LAKE HAVASU CITY, ARIZONA

ADDENDUM NO. 1

MAIN STREET COMMONS, BATHROOM & CONCESSIONS BUILDING PROJECT Project B26-PW-101009-500676

DATED: JULY 30, 2025

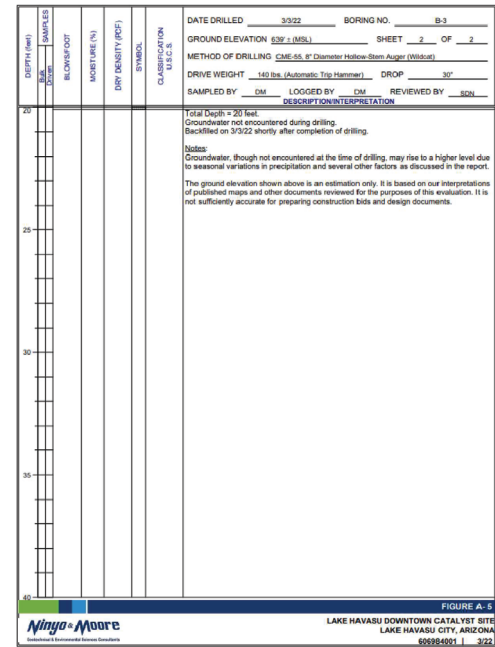
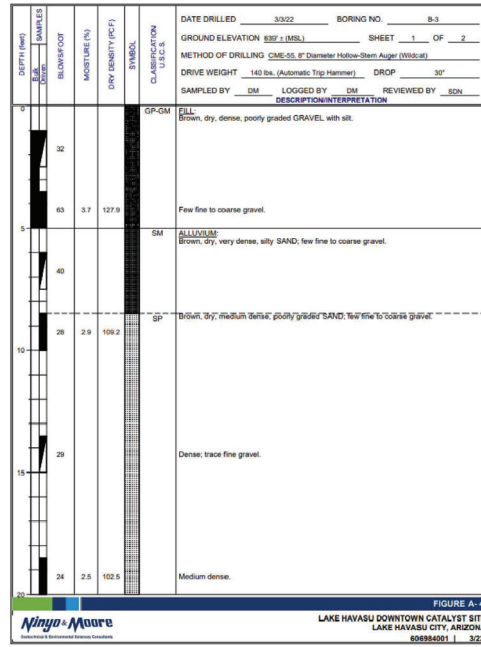
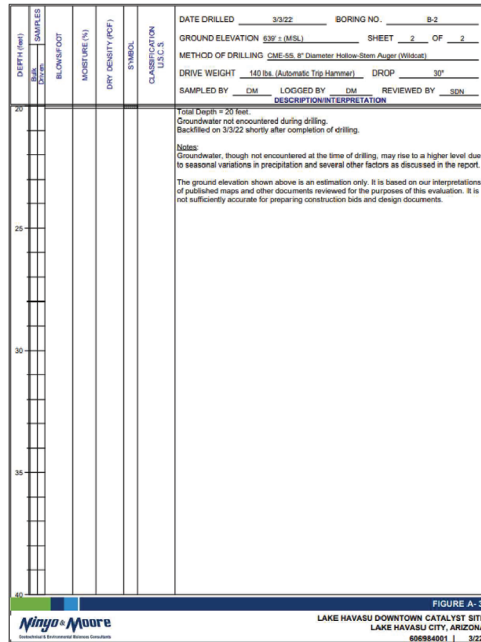
25. **Question:** *“Grading Requirements- What is the building pad foundation requirements for these buildings. There is no grade elevations provided for the*

buildings. Any depth of clean fill sand required under slab or just overexcitation and compaction of native soil?"

Answer: The exterior elevation sheets of both buildings show existing grade to be at a generic elevation of 100'. This is existing ground.

1
E001
ELECTRICAL SITE PLAN
SCALE: 1" = 20'-0"

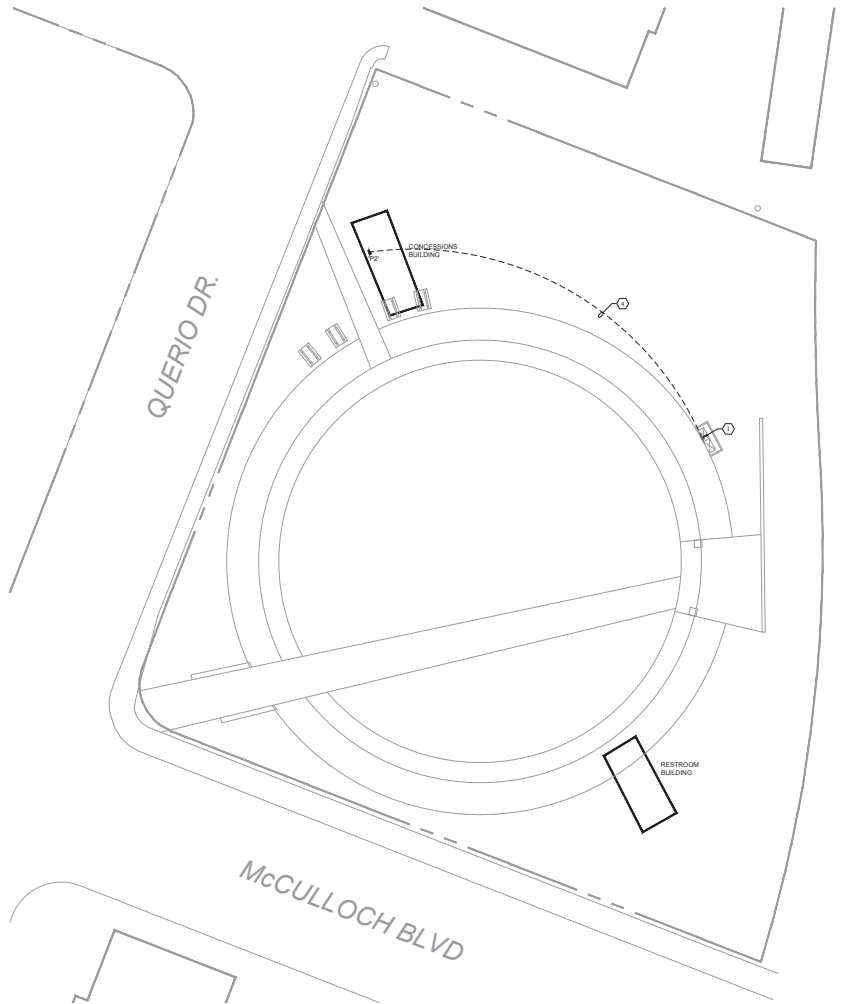
15. **Question:** *"May you tell us where the UniSource connection point will be."*

16. **Question:** *"Can you please provide some clarification on the Unisource connection point and the single line drawings for electrical."*

Answer: Sheet E001 of the Main Street Commons- Concessions plan shows the location of the connection point.

Answer: Sheet E001 of the Main Street Commons- Concessions plan shows the location of the connection point.
